Service Bulletin No. 424B

<i>MODEL</i>	D / J4500 Series	<i>TYPE</i>	Field Change Program	<i>SECTION/GROUP</i>	8-Engine	<i>DATE</i>	Aug. 27, 2015
<i>SUBJECT</i>	CUMMINS ISX LUBRICATING OIL FILTER BYPASS VALVE						
<i>CONDITIONS</i>

THIS BULLETIN SUPERCEDES SERVICE BULLETIN 424 IN ITS ENTIRETY.

Figure 1. Location of lubricating oil filter bypass valve on roadside of engine.

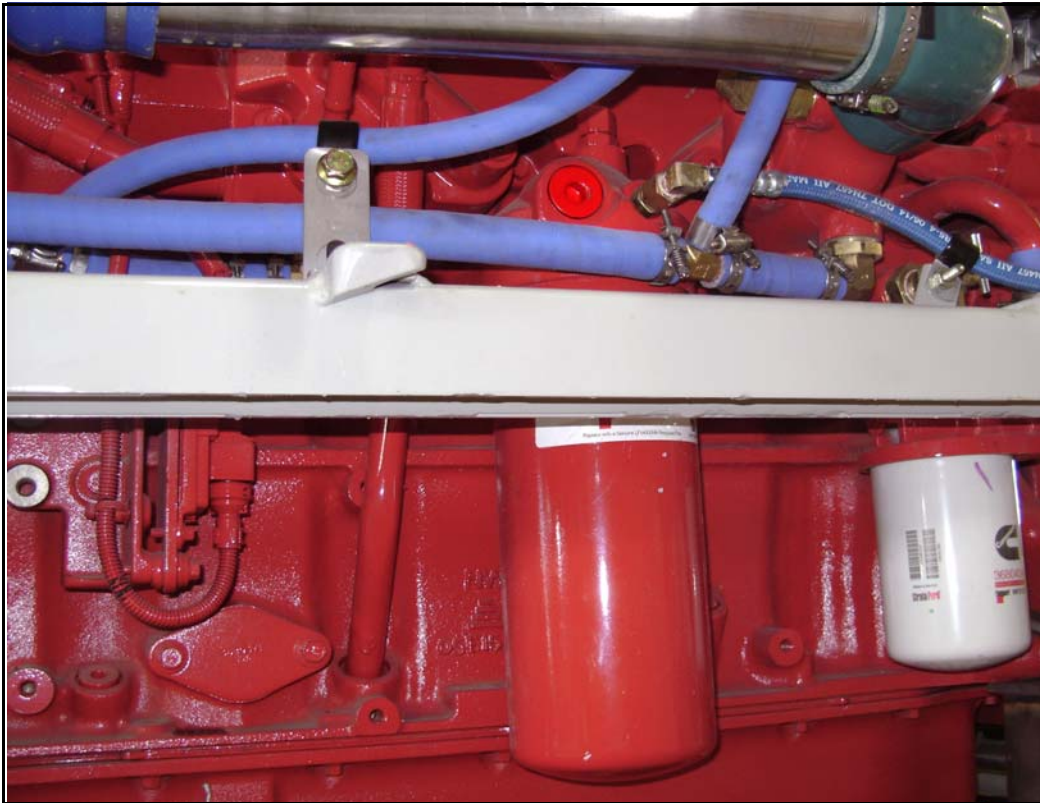
Cummins Inc. has notified Motor Coach Industries ("MCI") that it has issued a campaign to address the ISX lubricating oil filter bypass valve, in addition to the previous fuel pump repair actions outlined in MCI FCP Bulletin 424 and Cummins Field Campaign C1556.

The new bypass valve has more effective sealing capability and provides better protection to fuel pump lubricated components.

3. Proceed with Step 1 of the attached Cummins Installation Instruction Number 4908439 / Lubricating Oil Filter Bypass Valve Procedure, following all warnings and cautions therein.

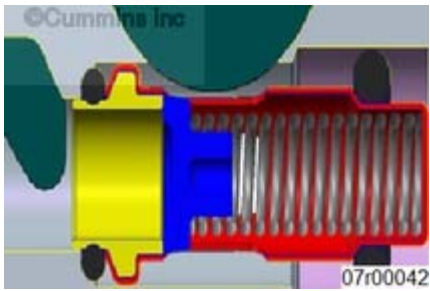
Inspect new lubricating oil filter bypass valve to verify two o-rings are correctly installed as shown.

Lubricate the lubricating oil filter bypass valve with clean engine oil.

Insert lubricating oil filter bypass valve into lubricating oil cooler housing. Marking stating "THIS END OUT" **must** be visible.

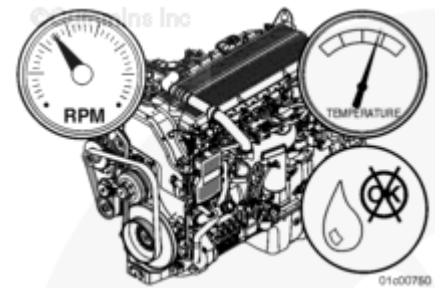
<p>If installing new lubricating oil filter bypass valve for the first time, clearly mark entire face of retaining plug using a high quality paint marker that is highly visible (such as yellow or white). Liberally apply paint marking.</p>	
--	--
